## TEXAS COMMISSION ON ENVIRONMENTAL QUALITY

NAME OF PROJECT: **Johnson Ranch**; Located at the northeast corner of the intersection of US 281 and FM 1863; Bulverde, Texas

TYPE OF PLAN: Request for Modification of an Approved Water Pollution Abatement Plan (WPAP); 30 Texas Administrative Code (TAC) Chapter 213 Edwards Aquifer

RE: Johnson Ranch WPAP Modification

Attachment B

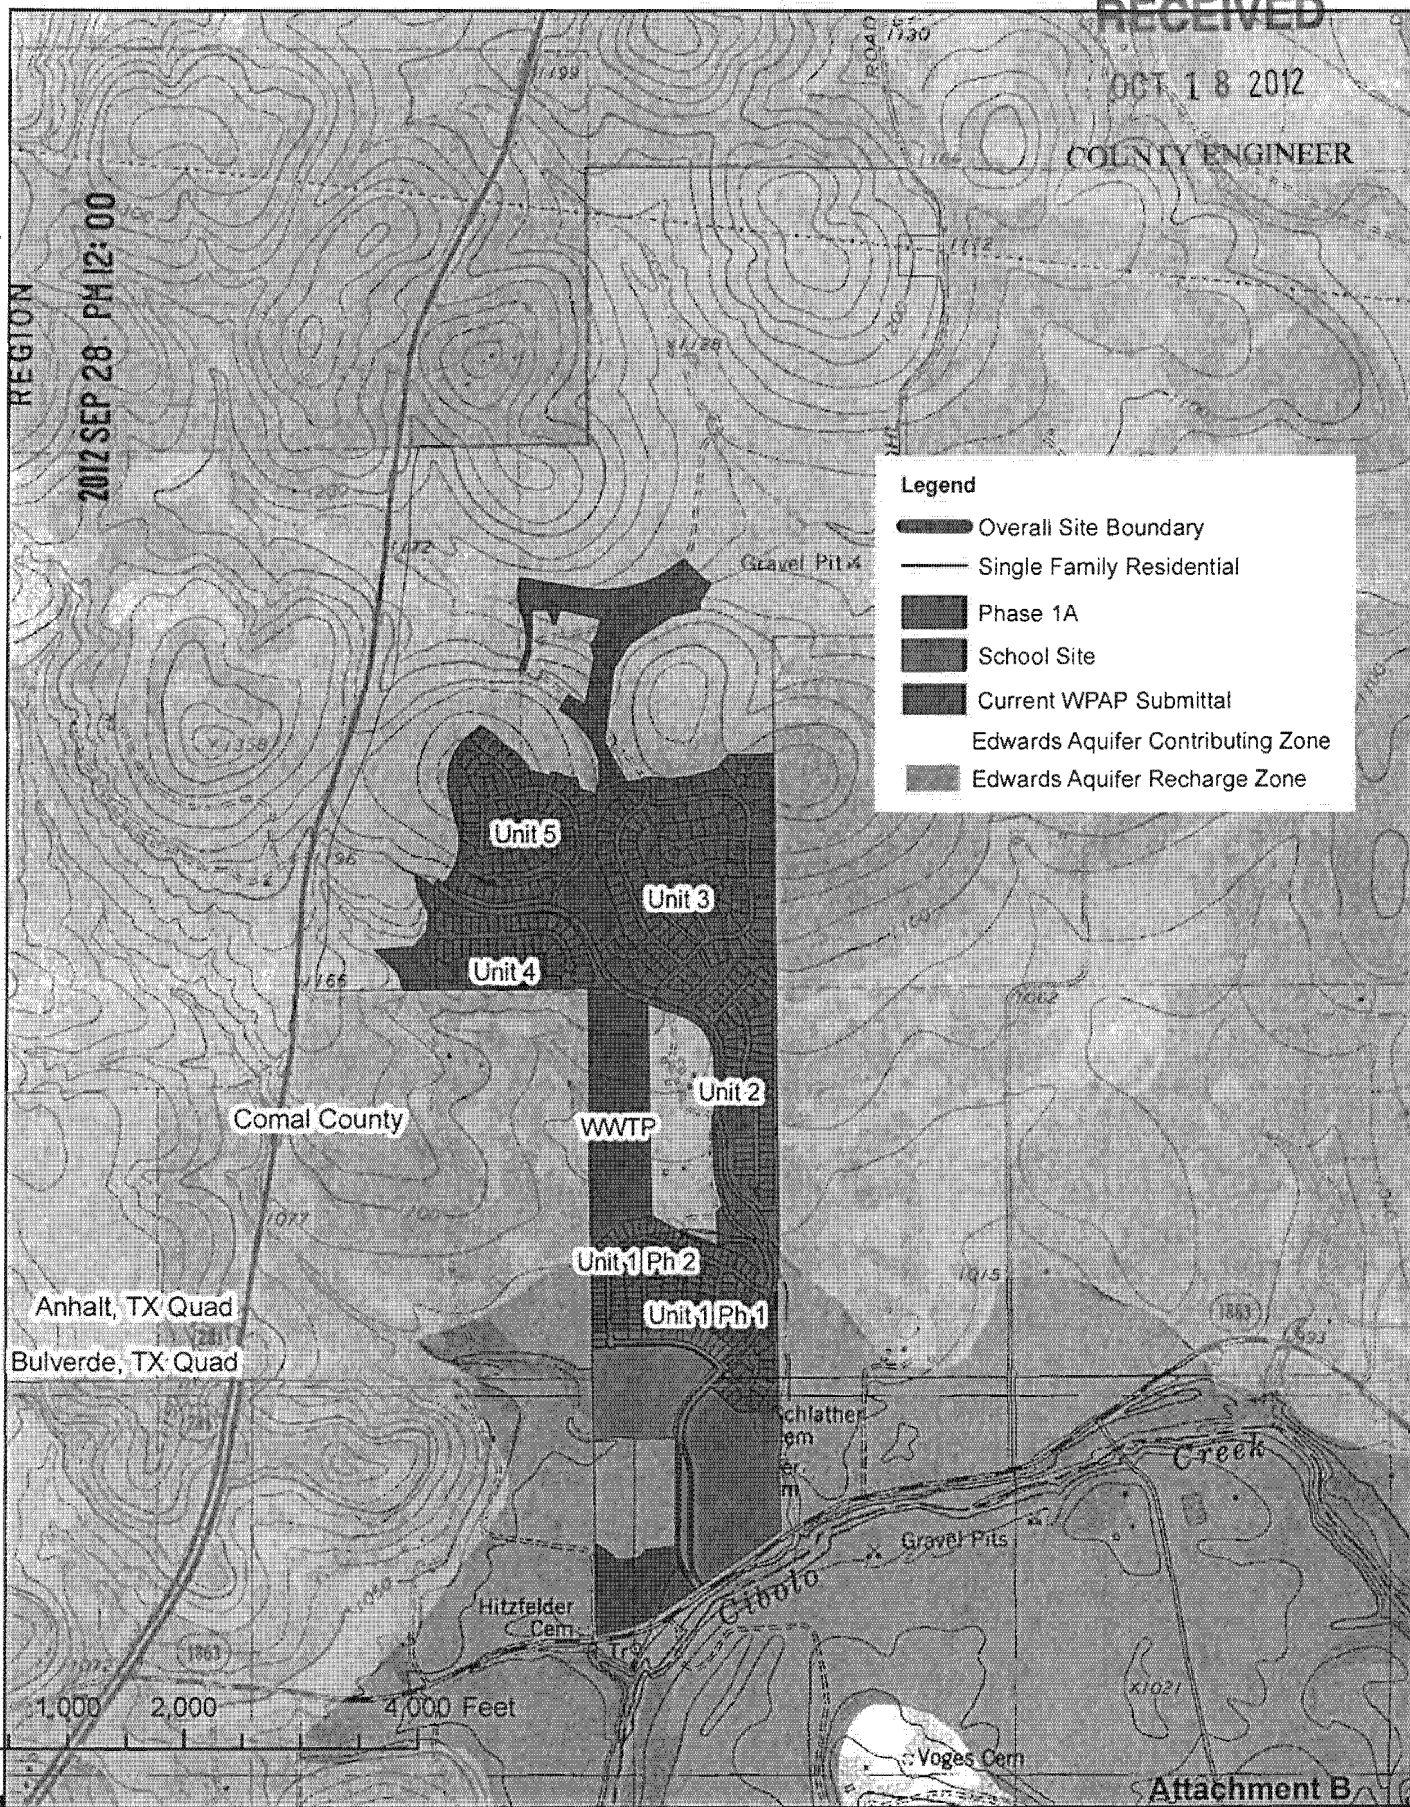
1. Please revise Project Description (Attachment C/General Information Form) to include reference to the actual modification including Unit 1 (Phases 1 and 2), Unit 2, Unit 3, Unit 4 and Unit 5 for clarification to reader. Revising the Attachment B (General Information Form) map to show the location of Units 1 through 5 would be most helpful to the reader.

**Response: Attachments B and C of the General Information Form have been revised as requested and are attached.**

Attachment B

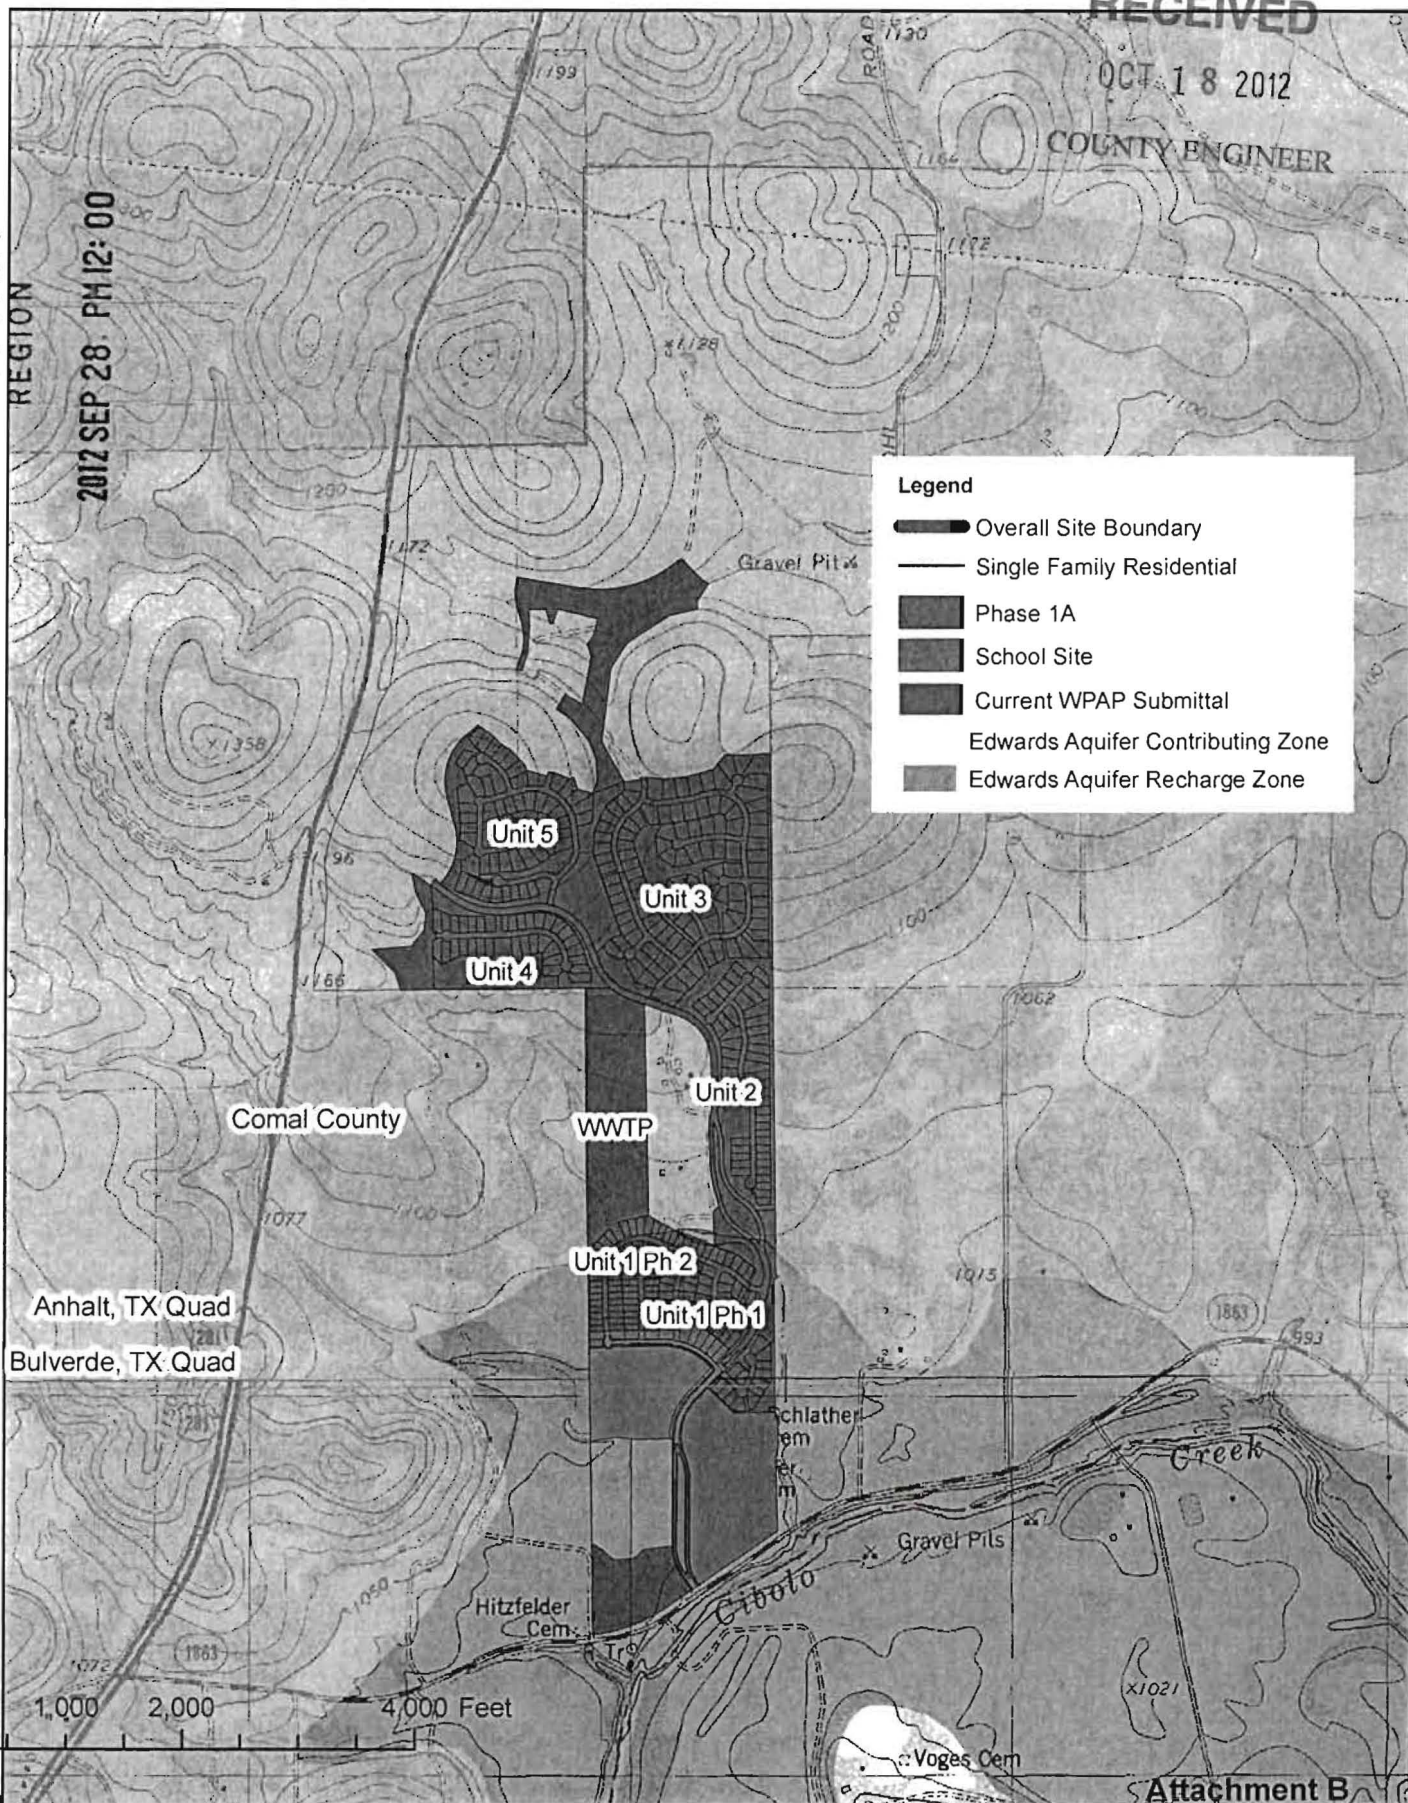
1. Please revise Project Description (Attachment C/General Information Form) to include reference to the actual modification including Unit 1 (Phases 1 and 2), Unit 2, Unit 3, Unit 4 and Unit 5 for clarification to reader. Revising the Attachment B (General Information Form) map to show the location of Units 1 through 5 would be most helpful to the reader.

**Response: Attachments B and C of the General Information Form have been revised as requested and are attached.**
